Product Change Notification / GBNG-09ECUY508

CCB 5249 Final Notice: Qualification of MTAI as an additional assembly site for selected ATECC108A, ATECC508A, ATSHA204A, ATECC608A, ATECC608B and ECC608-TFLXWPC device families available in 8L SOIC (3.90mm) package using QMI519 die attach material.

CCB 5249
Pre and Post Change Summary
PCN #: GBNG-09ECUY508

ASSH

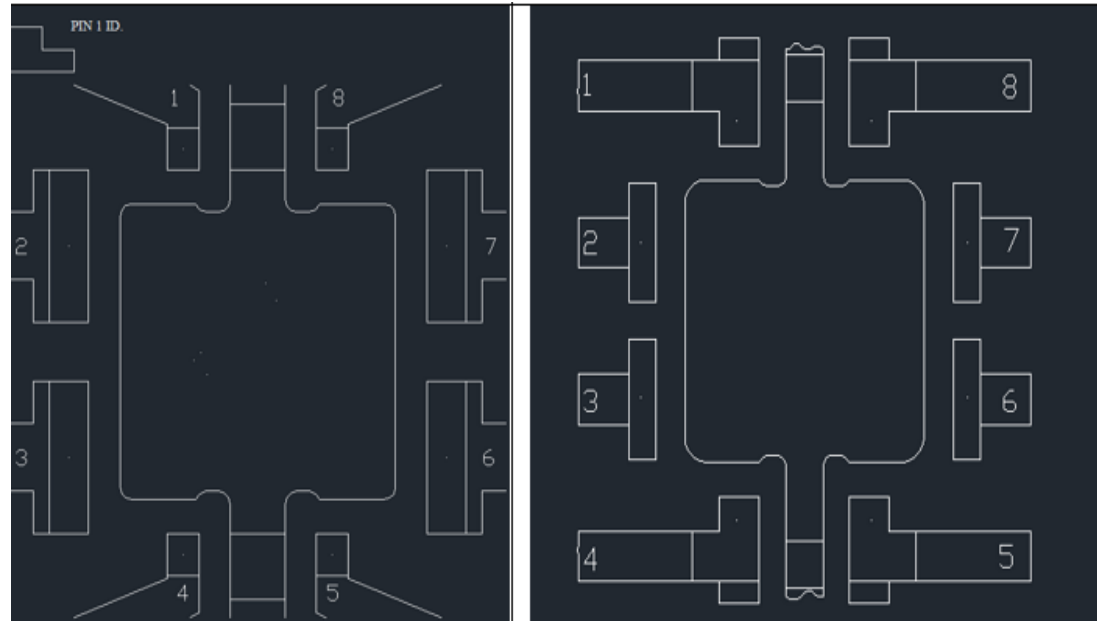
Lead frame DAP surface prep	PPF
Lead Plating	NiPdAu
Lead-Frame Paddle Size	70 x 70 / 90 x 90

MTAI

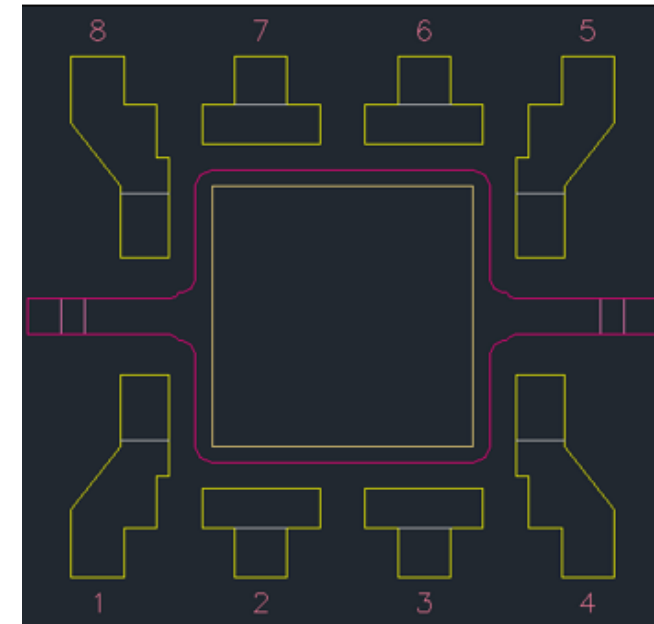
Lead frame DAP surface prep	Bare Cu
Lead Plating	Matte tin
Lead-Frame Paddle Size	90 x 90
